**Manatee County Solid Waste Management Facility
Lena Road Class I Landfill
3333 Lena Road, Bradenton, Florida 34211**

**APPLICATION AND ENGINEERING REPORT FOR
RENEWAL OF THE CLASS I LANDFILL
OPERATION PERMIT**

RE: Lena Road Class I Landfill Operation Permit Renewal
Pending Permit No.: 39884-018-SO/01, Manatee County
WACS ID No.: SWD-41-44795

IPR NO.: 8769
SCALE: 1" = 200'
DRAWN BY: DSR
DATUM: STATE PLANE FLORIDA EAST ZONE NAD 83
REVISED:

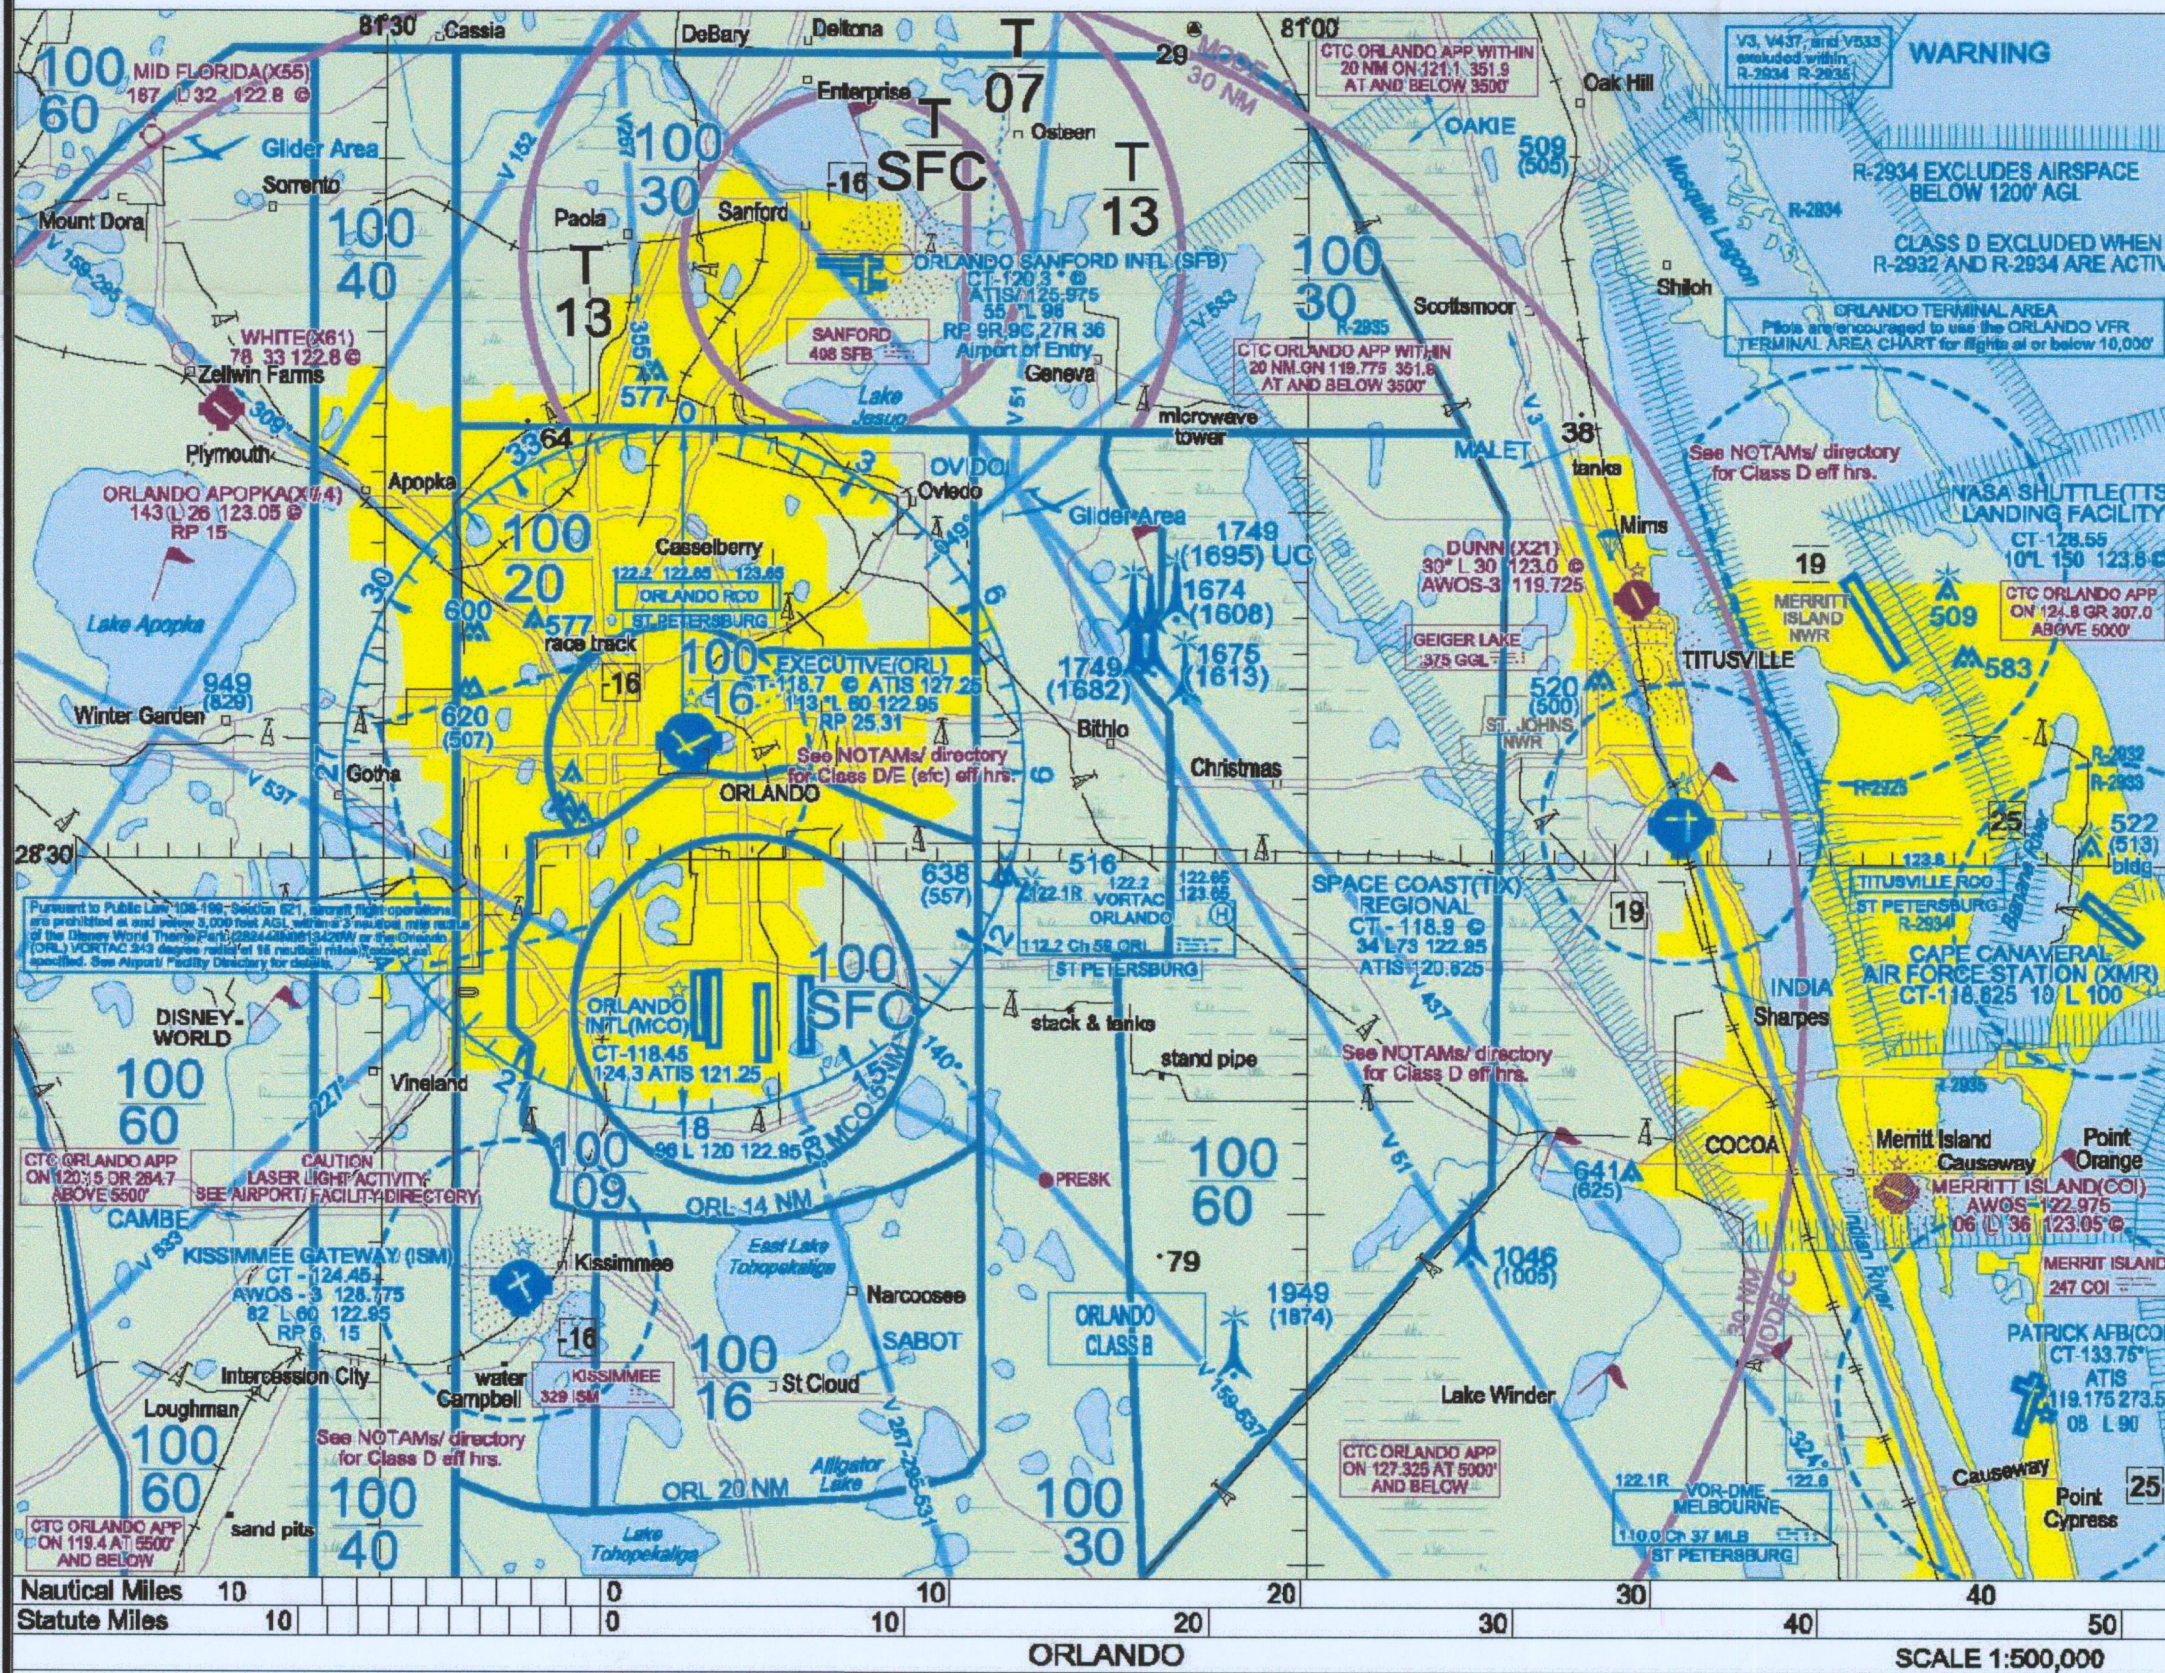
24. **Sheet C-3:** Please provide a copy of the topographic survey of the facility signed and certified by the professional surveyor that prepared the survey.

Response: Sheet C-3 was revised to include the topography from the 2010 aerial photograph. A copy of the topography signed and sealed was included with this response.

FIGURE K-4
LEACHATE COLLECTION SYSTEM

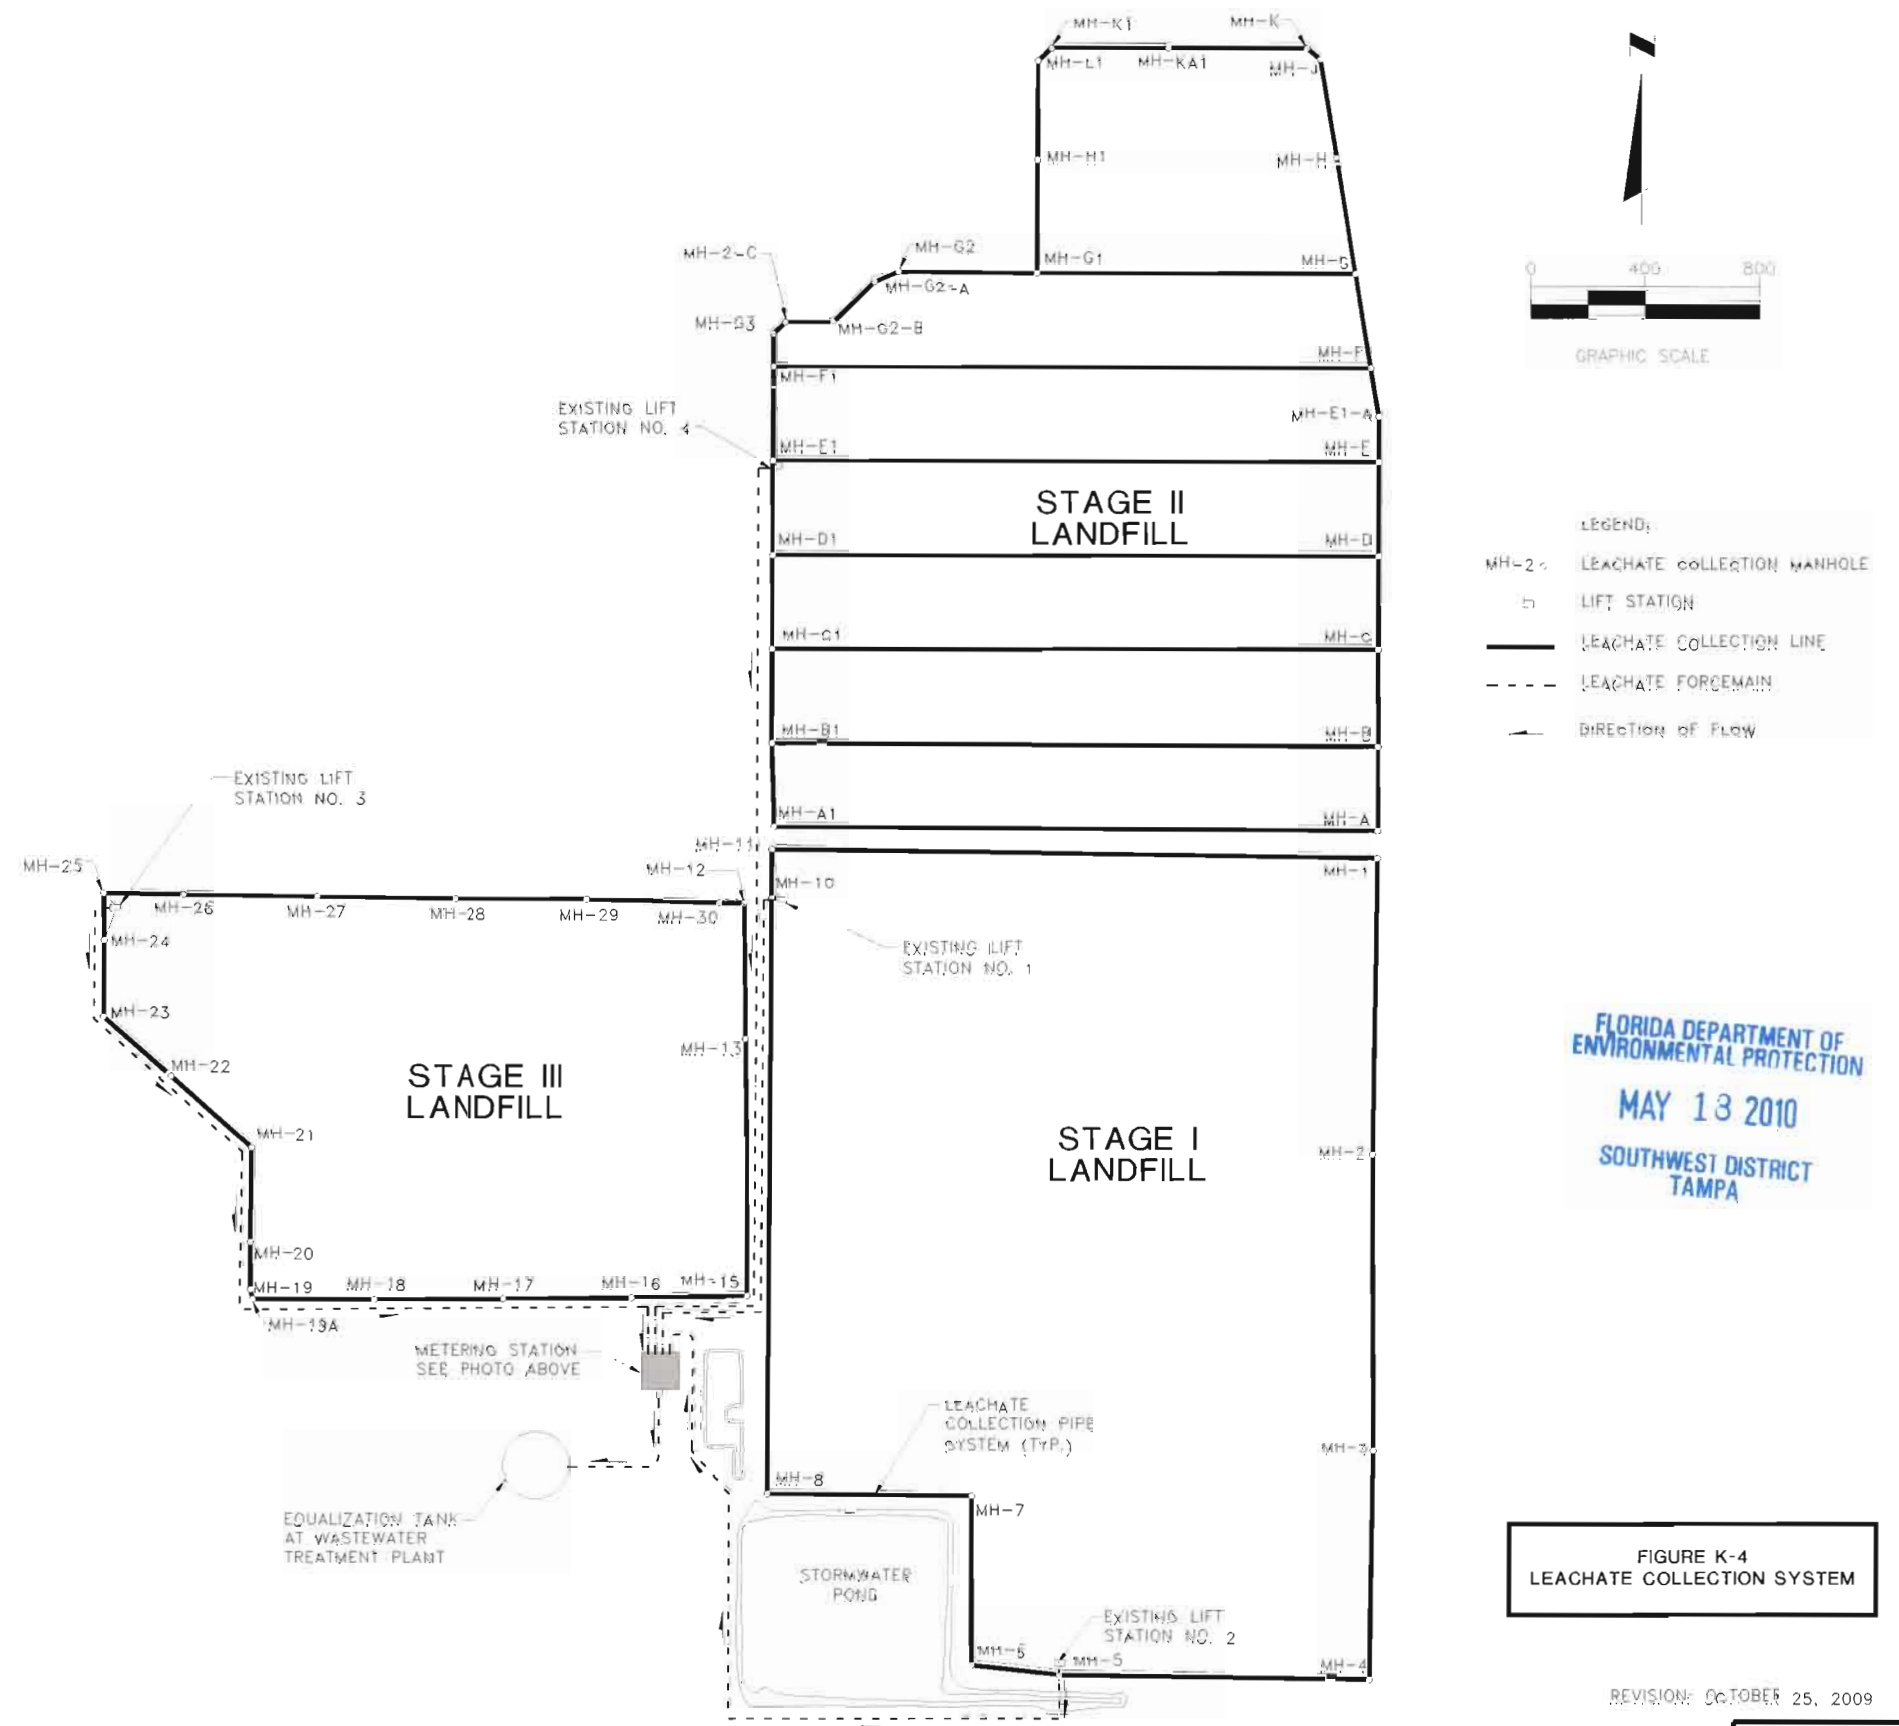
d. Figure L-4-A: Please provide a revised figure(s) that identifies each of the numbered components on this figure, including the leachate meters.

Response: A photograph of the meter installation was added to Figure K-4. The photograph shows each meter with the pump station identified for each specific meter.
